Product Advisory

Published 1-20-11

New Adjustable Safety Clamp for 3/4" - 1 1/4" Mueller® NO-BLO® Valve Changers

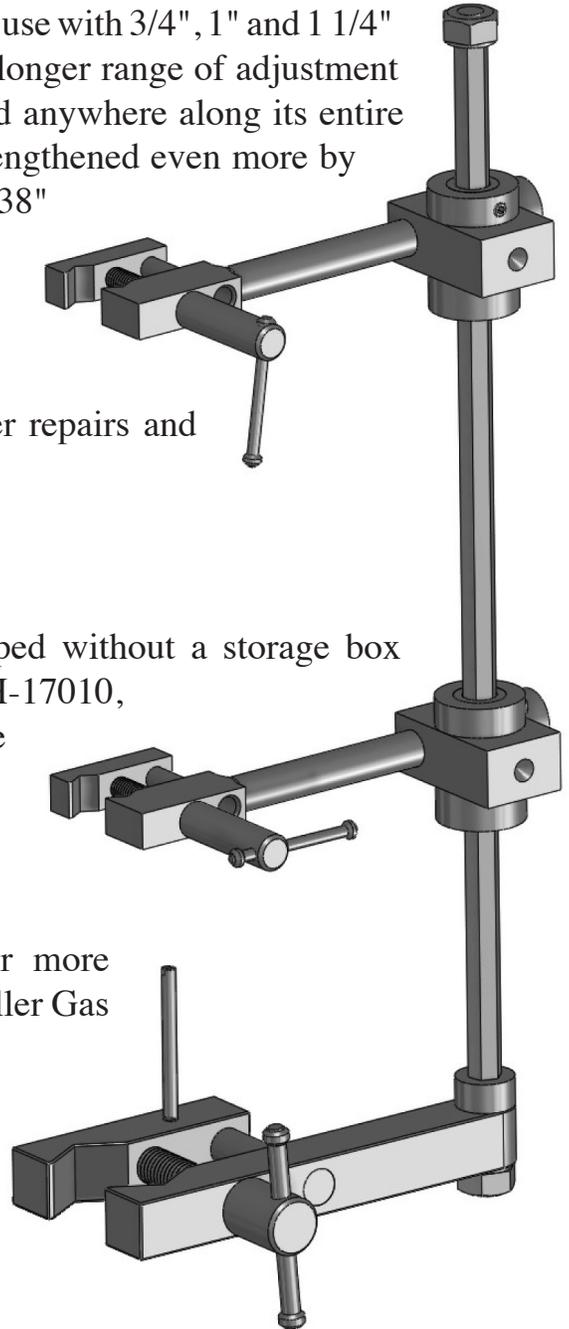
Mueller now offers a newly redesigned Safety Clamp for use with 3/4", 1" and 1 1/4" NO-BLO Valve Changers. The improved design has a longer range of adjustment allowing the two plugging unit clamps to be positioned anywhere along its entire operating length. In addition, this new design can be lengthened even more by replacing the standard 20" clamp bar with an optional 38" extended length clamp bar.

- Full adjustment of plugging unit safety clamps.
- Added flexibility to work with service head adapter repairs and other unconventional situations.
- Less weight.
- Easy conversion to extended 38" length.

The new safety clamp (part number 682597) is shipped without a storage box unless ordered with the following valve changer kits: H-17010, H-17013, H-17017. An additional storage chest can be purchased by ordering part number 680350. To convert to extended 38" length, order the Extended Clamp Bar (part number 682795).
